**GFA AD 514**

# **GFA AIRWORTHINESS DIRECTIVE**

LS-7, all models, all serial numbers.

Obstruction of emergency canopy jettison.

## Deflector with edge protector:

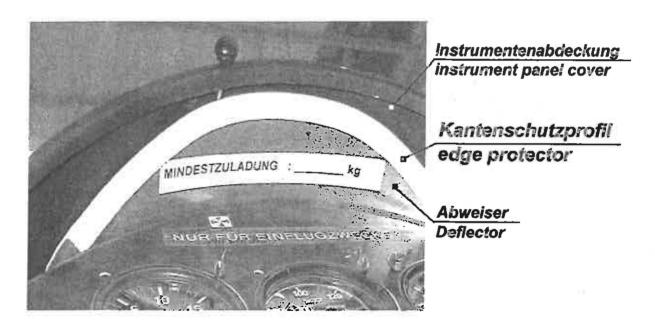
- 1. Drill blind rivets. If need be, unscrew upper instruments (Hexagon head 2.5 mm und ratchet with 7mm socket) and place them on top of the second row.
- 2. Mark new fixing holes 10mm (0.4 in) offset from originals and drill. This enables to use the existing holes at the instrument panel edge.
- 3. Shorten straight edge of deflector by 10 mm, soften edge and paint black. Maximum depth of deflector after trimming is 100 mm (3.94 in).
- 4. Rivet deflector back to top of instrument panel, facing towards the pilot (Blind rivets Ø 4mm\*6.5, large washers Ø4.3 \* 12 \* 1mm DIN 9021-St).
- 5. Push edge protector (as long as instrument panel allows) onto deflector edge.
